# City of Alexandria, Virginia

## MEMORANDUM

**SUBJECT:** CONCEPT REVIEW OF 805, 809, 811, 815, and 823 NORTH COLUMBUS  
STREET  
BAR #2021-00048

**Figure 7: Massing diagram of Madison Street elevation**

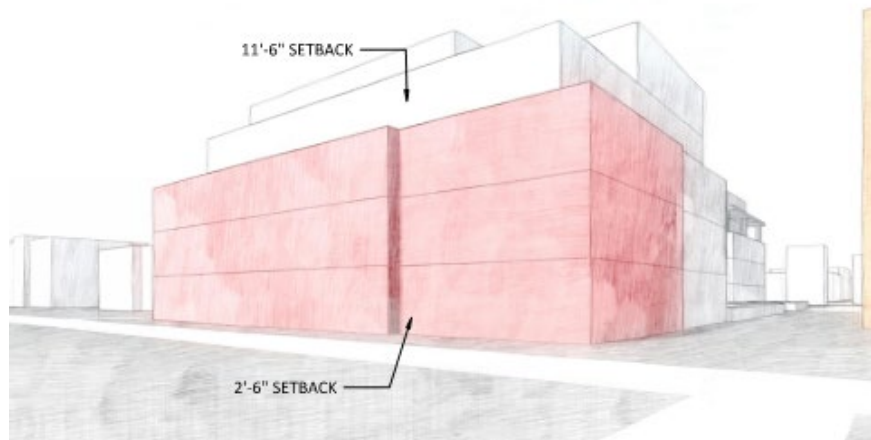
The south elevation of the building features a 2'-6" deep setback at the eastern third of the elevation (Figure 7 above). This setback helps to break up this massing and provides additional ground space at the eastern edge of the building. As currently designed, this step in the building is continued on the fourth floor, creating a terrace that follows the outline of the floor below. Where this helps to articulate the lower floors, it draws unwanted attention to the upper level. Staff recommends that the exterior wall of the south end of the fourth floor be pushed back from the edge of the lower floor and straightened (Figure 12). This will provide a more generous setback and further simplify the upper form.

**Figures 12 & 13: Fourth and Fifth Floors showing revisions to simplify exterior form**

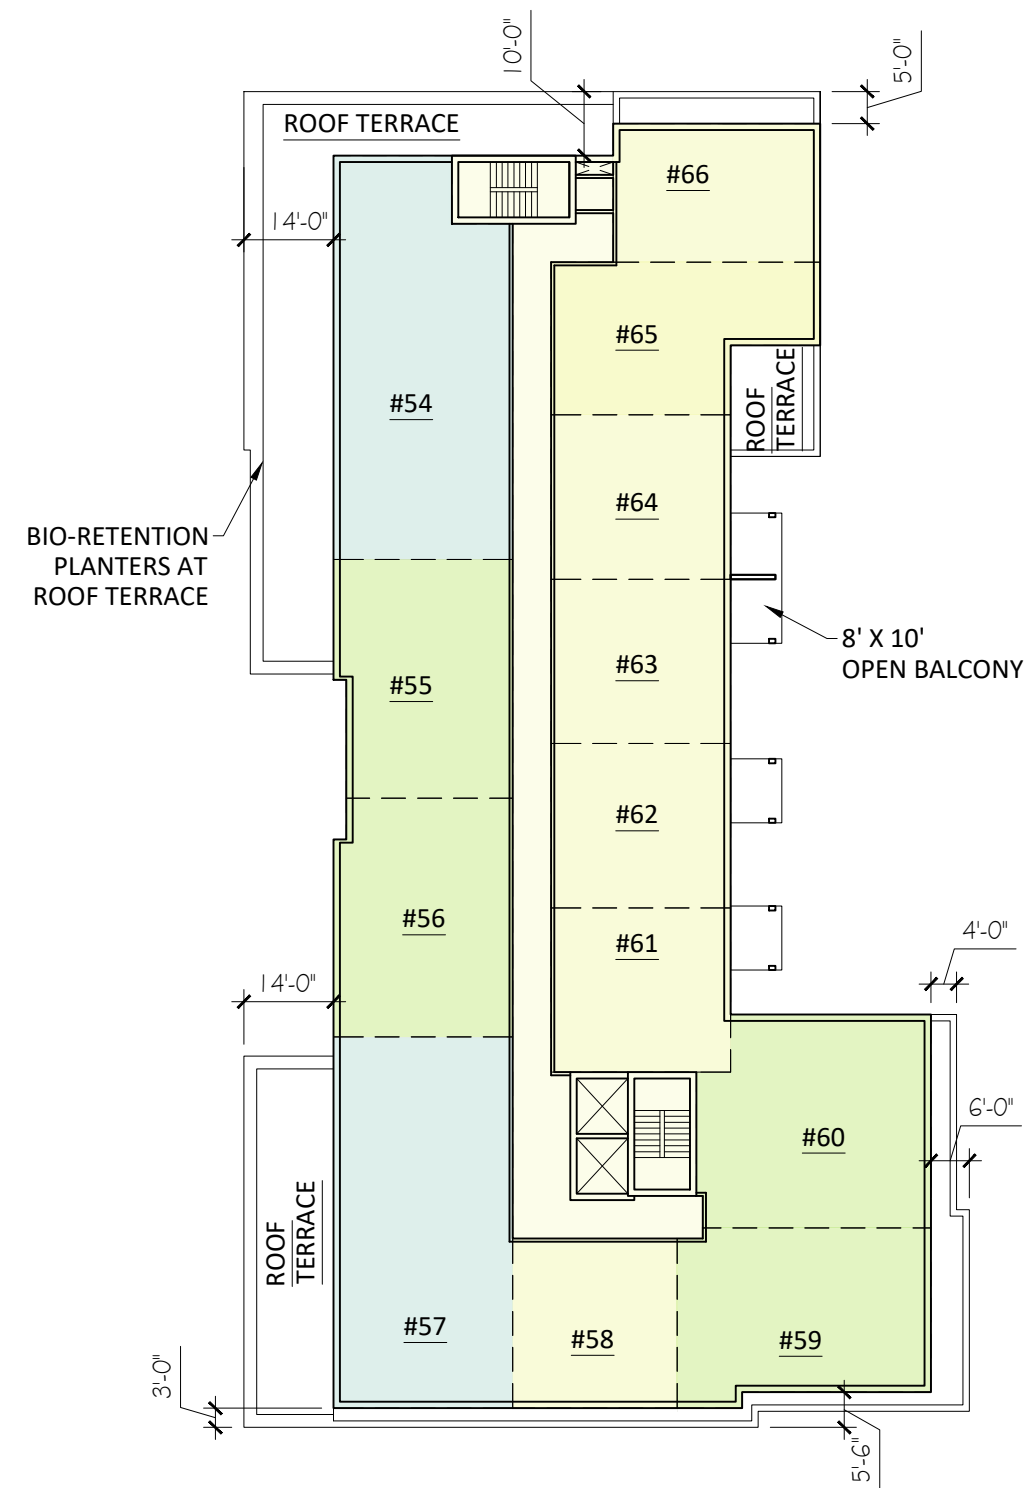
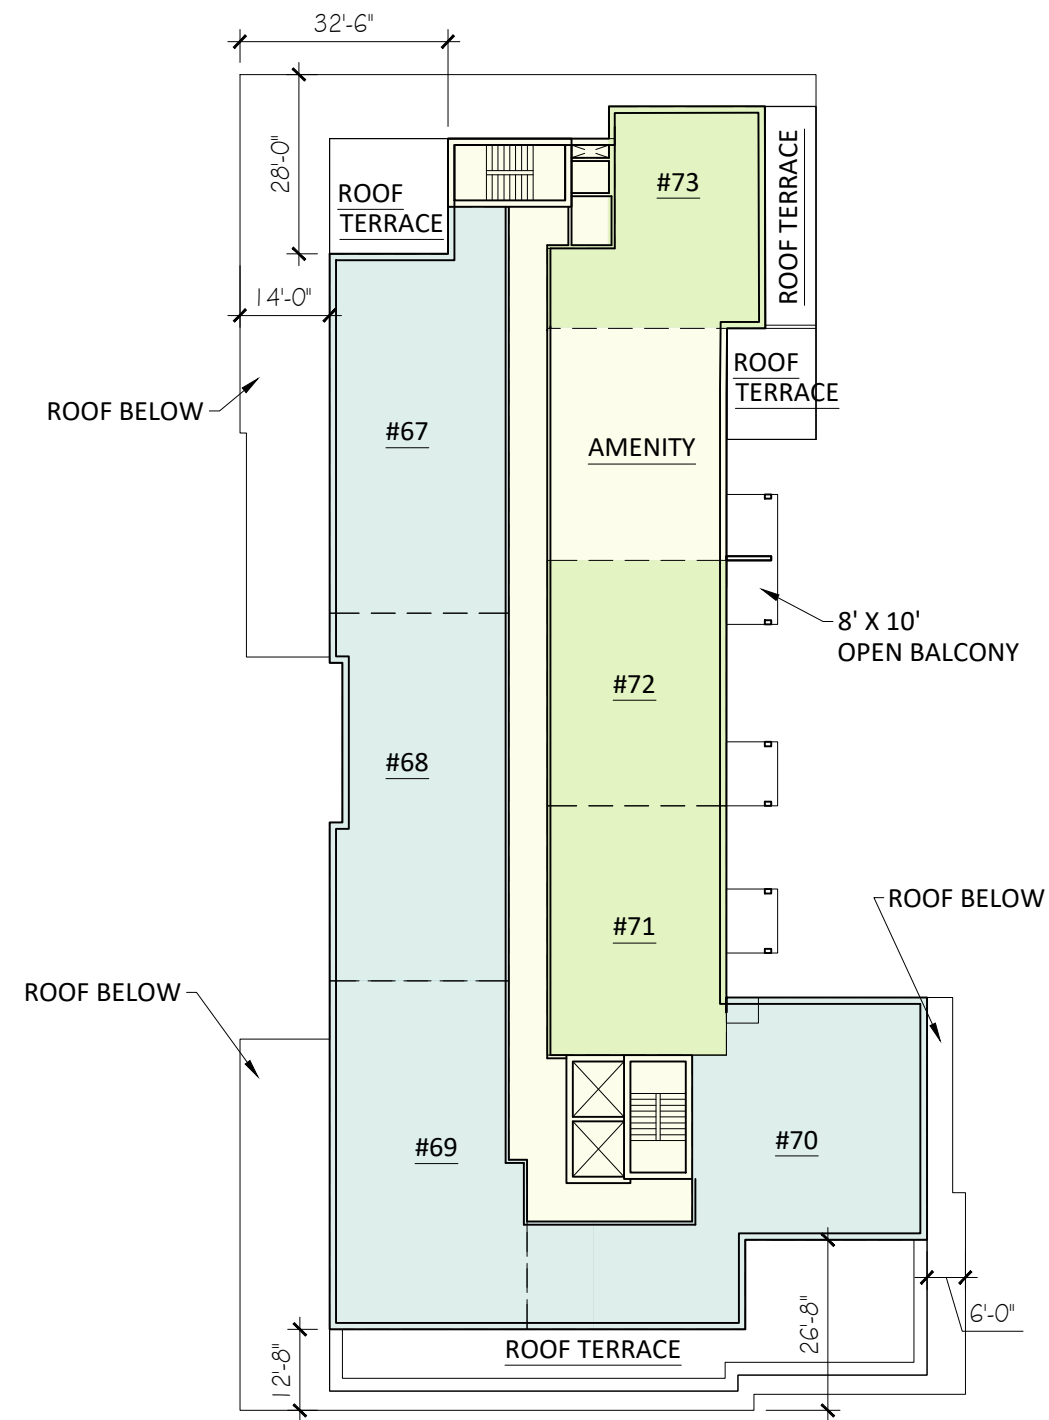
At the fifth floor this straightened elevation should be continued and Staff recommends that the applicant explore ways in which the setback can be increased to create a larger rooftop amenity with direct access from the building corridor adjacent to the building elevators. It could be possible to divide this rooftop amenity into spaces dedicated to units but this move would further simplify the upper level form by eliminating one of the steps in plan and would give additional porosity to the south elevation of the upper level.

At the northwest corner of the fifth floor the proposed design includes a private roof terrace that is created by taking a notch out of the corner of this portion of the building. This creates an awkward juxtaposition with the protruding portion of the north end of the plan on the other side of the stair. As with the steps at the south side of the building, this notch creates visual noise in this background building, drawing attention to the area. Staff recommends that the applicant enclose this corner to create a more balanced composition and simplify this portion of the building (Figure 13). If the applicant would like to maintain a private terrace in this location, one option would be to continue the exterior skin to form the corner but without a roof and windows in the punched openings. This would allow for this to be an exterior space while maintaining the simplicity of the building form.
